Broadway Reconstruction: Violet to US36

Update to Broadway Cross Section in North Boulder Subcommunity Plan

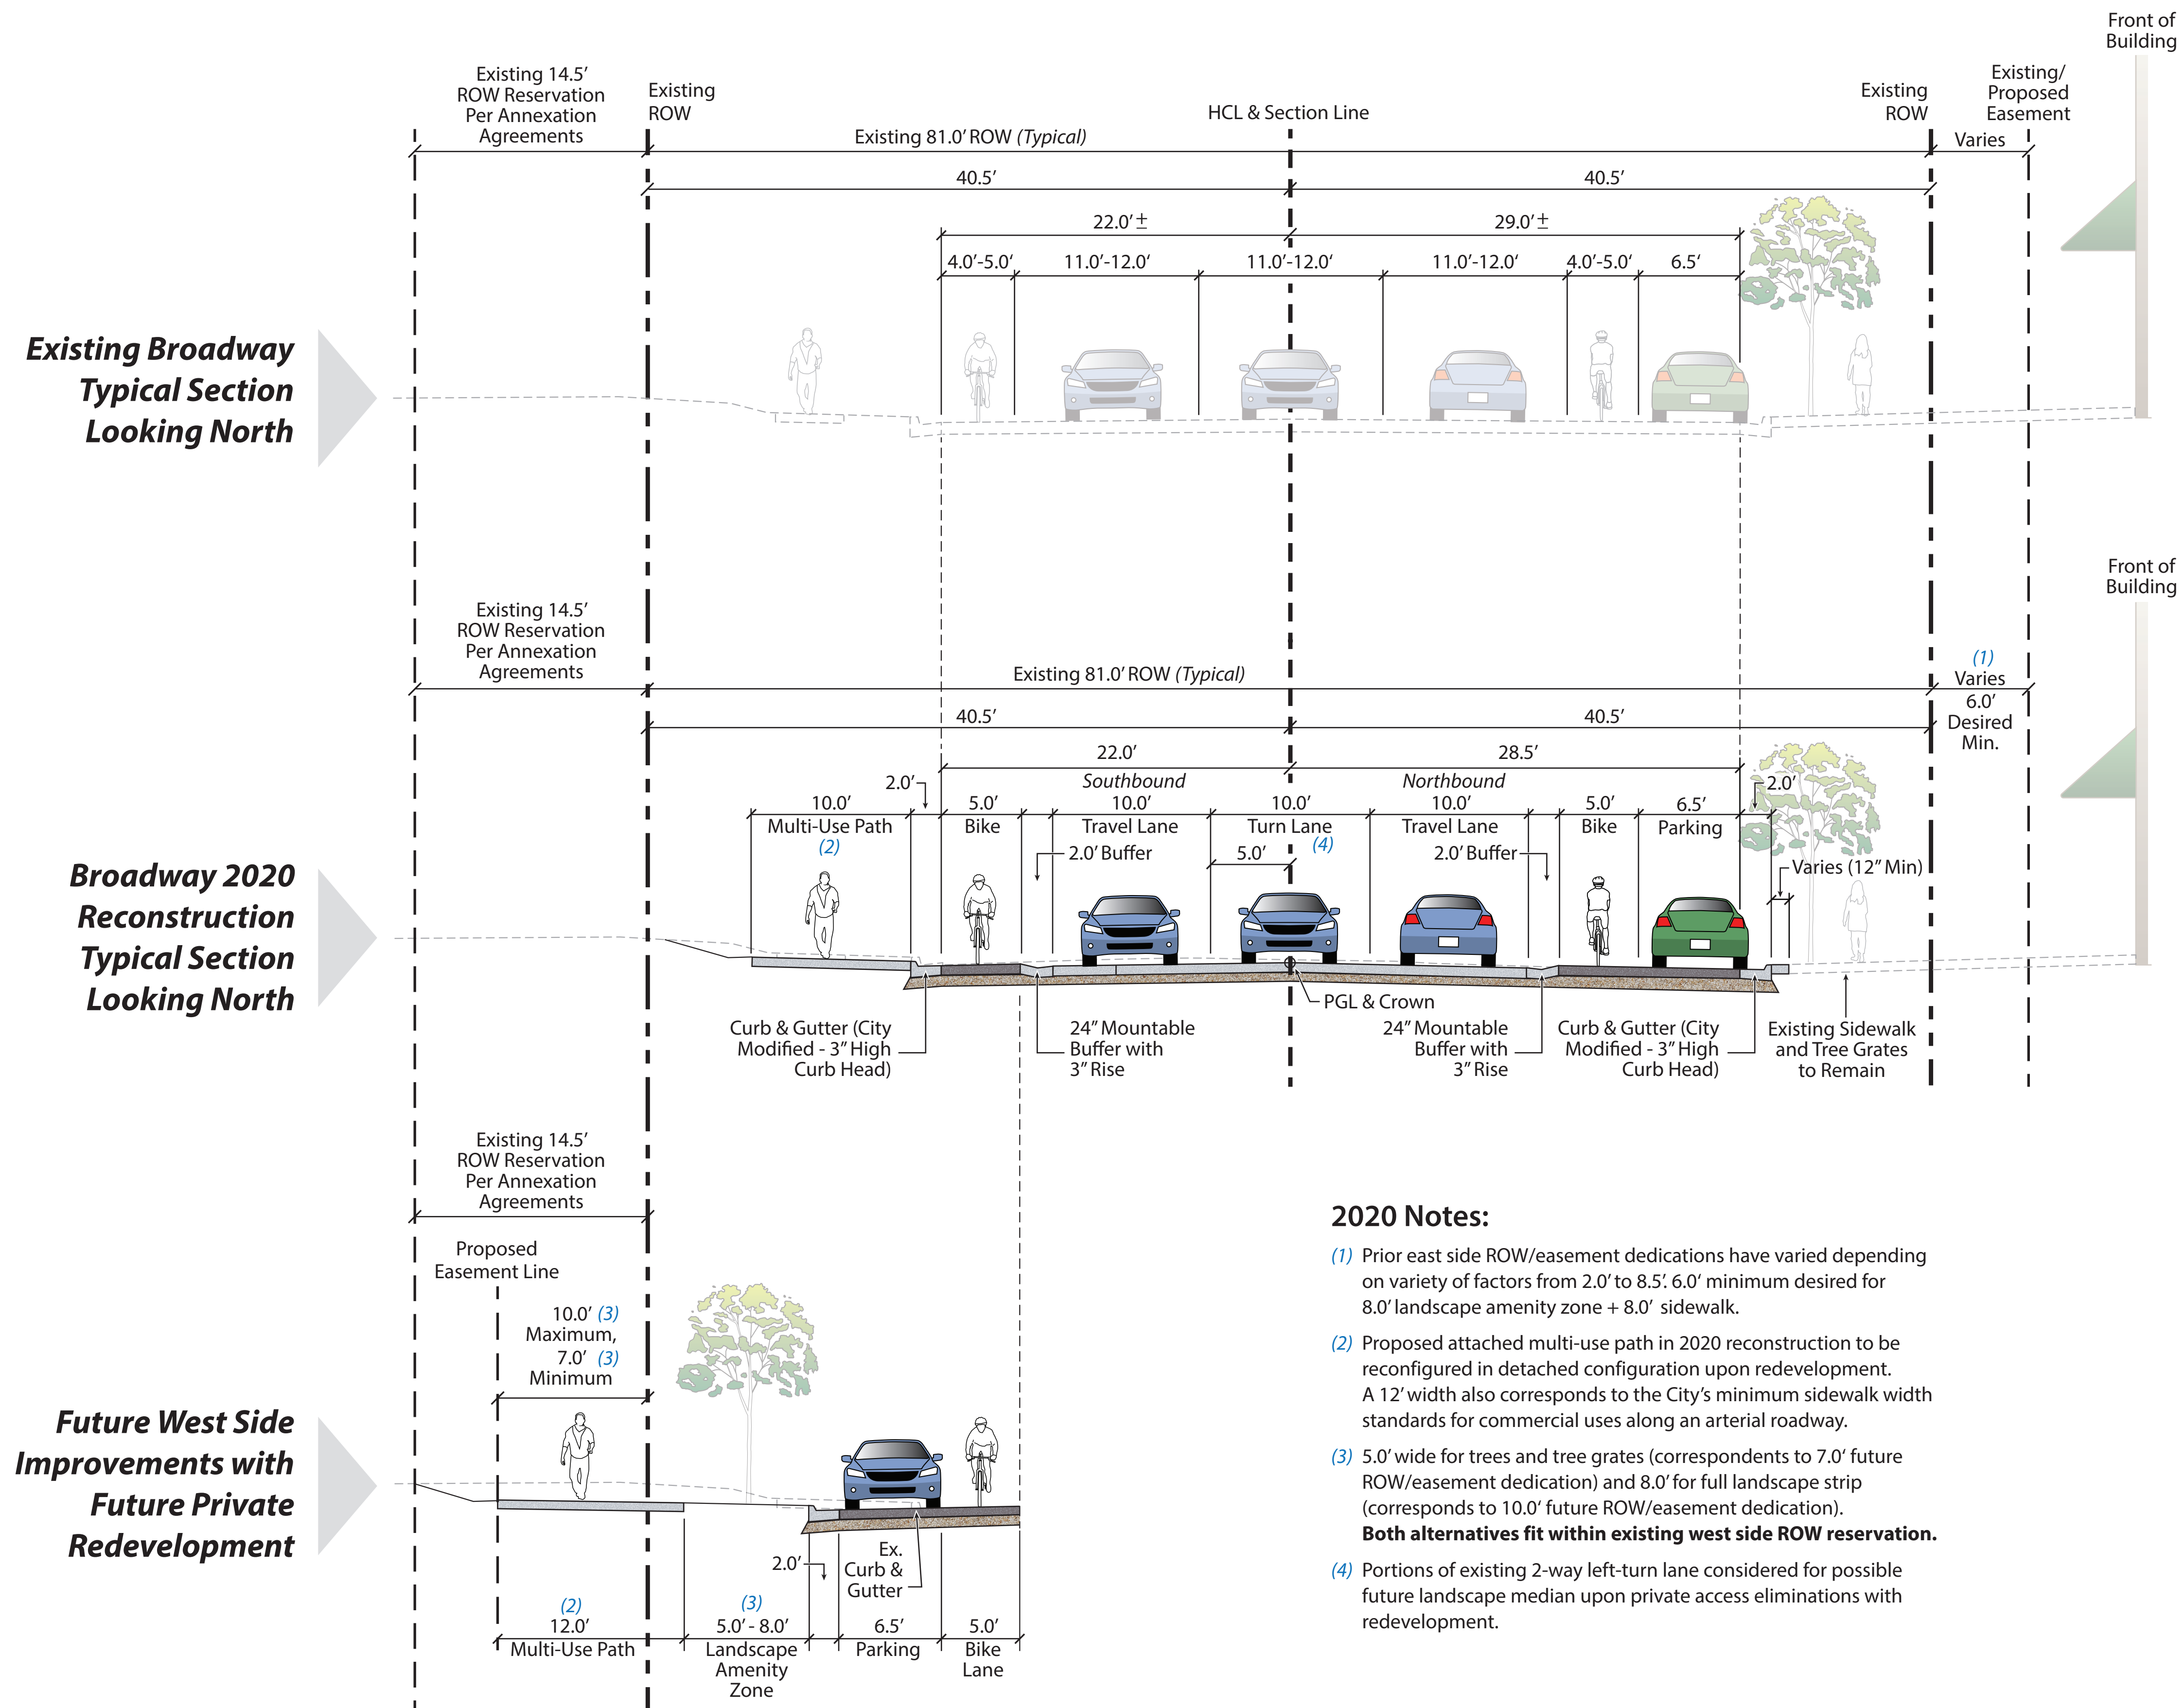
- (1) Prior east side ROW/easement dedications have varied depending on variety of factors from 2.0' to 8.5'. 6.0' minimum desired for 8.0' landscape amenity zone + 8.0' sidewalk.
- (2) Proposed attached multi-use path in 2020 reconstruction to be reconfigured in detached configuration upon redevelopment. A 12' width also corresponds to the City's minimum sidewalk width standards for commercial uses along an arterial roadway.
- (3) 5.0' wide for trees and tree grates (corresponds to 7.0' future ROW/easement dedication) and 8.0' for full landscape strip (corresponds to 10.0' future ROW/easement dedication). **Both alternatives fit within existing west side ROW reservation.**
- (4) Portions of existing 2-way left-turn lane considered for possible future landscape median upon private access eliminations with redevelopment.
